Subject: SQUEAKING NOISE AROUND REAR CENTER CONSOLE LID	Bulletin No: 09-026/06
	Last Issued: 6/27/2006

2006 MX-5 vehicles with VINs lower than JM1 NC**** ** 118186 (produced before May 10, 2006)

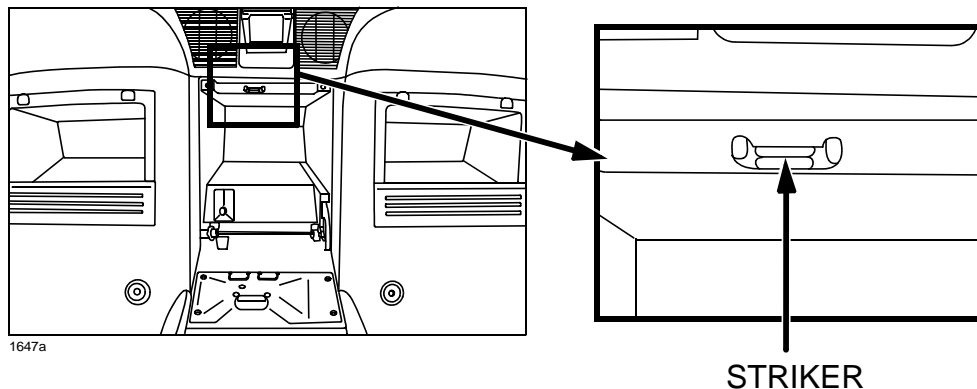
Some vehicles may exhibit a squeaking noise from around the rear center console lid area when driving on a rough road or turning corners at slow speeds. Torque of the rear center console lid striker screw is insufficient. The tightening process has been revised in production.

BACK TRIM WITHOUT STORAGE BOX LIDS SHOWN

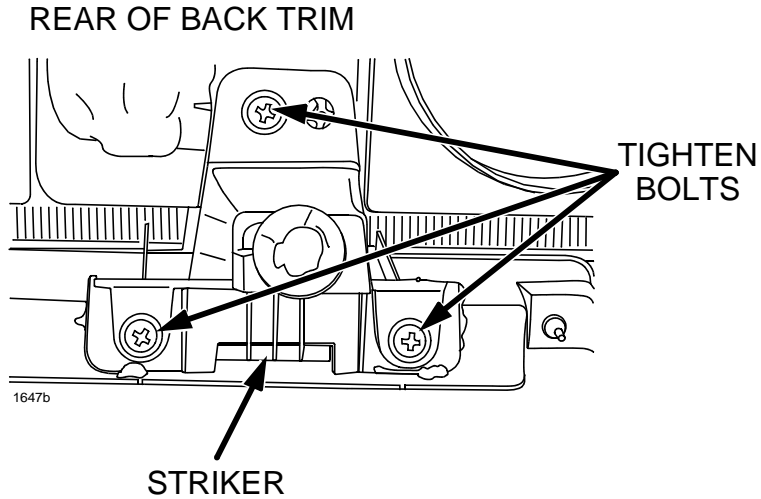
1. Verify customer concern.
2. Open the center rear console lid and grasp the striker to verify if there is any movement of the striker.
 - If there is movement, go to STEP 3.
 - If there is no movement, continue to diagnose source of squeak.

3. Remove the back trim. Refer to Workshop Manual section 09-17 BACK TRIM REMOVAL / INSTALLATION.

4. Tighten the 3 screws attaching the striker to the back trim.

5. Reinstall the back trim.
6. Verify repair.
